Client: Tinder EST: na WO: 8903 Version: 03 Date: 04.26.22 Sales Contact: TS Designer: F

Lobby Sign – Front View

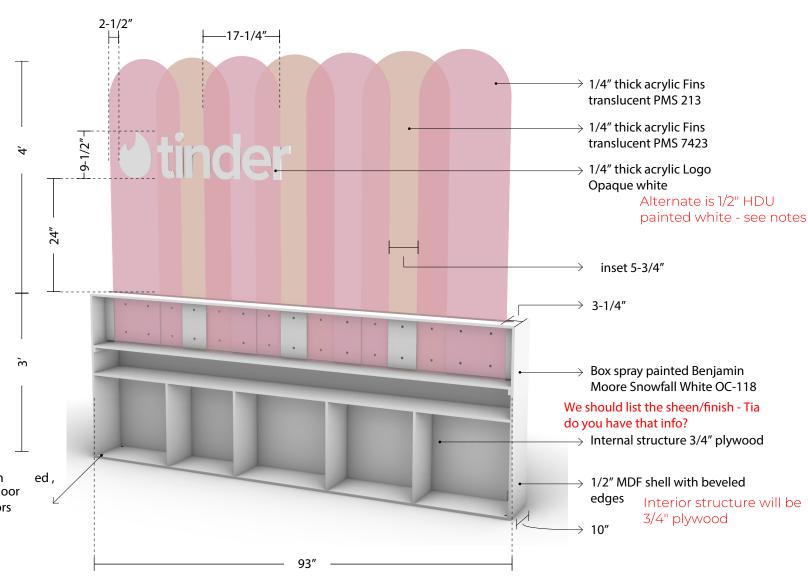
Indicate that this is a view of the internal structure

Please indicate that all dimensions listed on this page are final exterior dimensions and not the dimensions of the interior structure
